SERVICE BULLETIN

ENGINE - FUEL AND CONTROL - ENGINE - AIR SYSTEM - INCORPORATE A CHAMFER ON THE P4.9 PRESSURE CONTROL MANIFOLD ADAPTOR - CATEGORY CODE 3 - MOD.ENG-73-0001

V2500-ENG-73-0001

Pipes adaptor
Fig.1

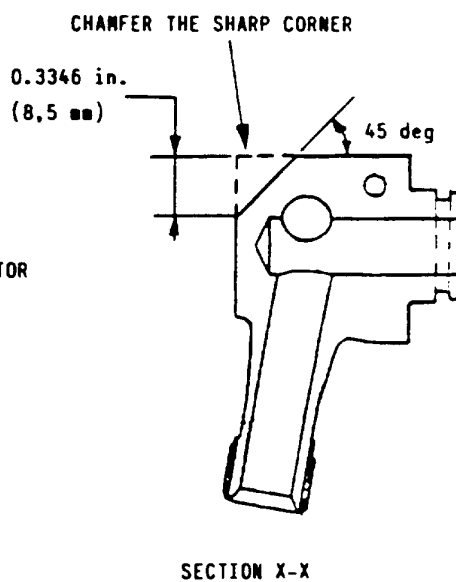
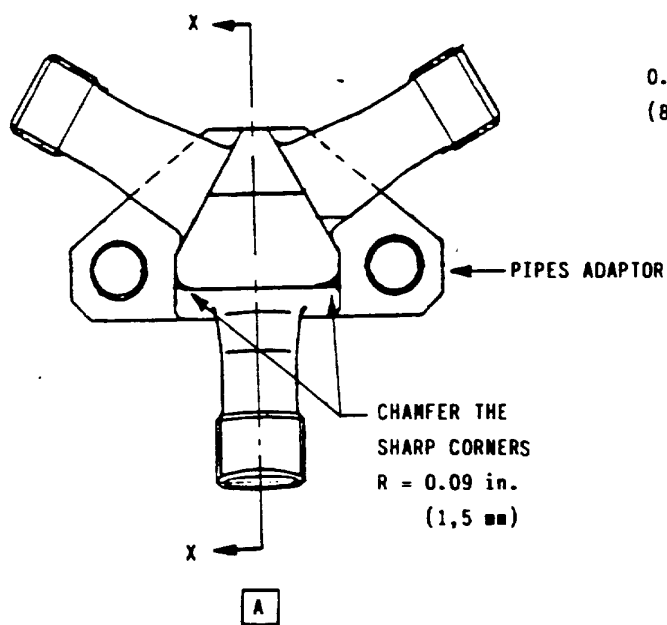
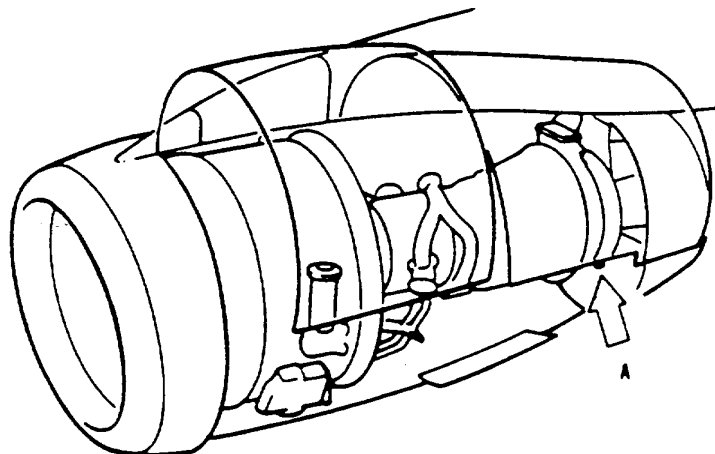
The sharp corners of the fitting are chamfered to avoid an interference with the C-duct rear of the bifurcation bumpers.

Procedure	Supplementary Information	
(a) Chamfer the sharp corners of the pipes adaptor. Use of hand tool (file) is permissible	Refer to Figure 1	
(b) Using a vibropeen, remove the old P/N and mark the new P/N	Old P/N	New P/N
	4P8089	4P8105
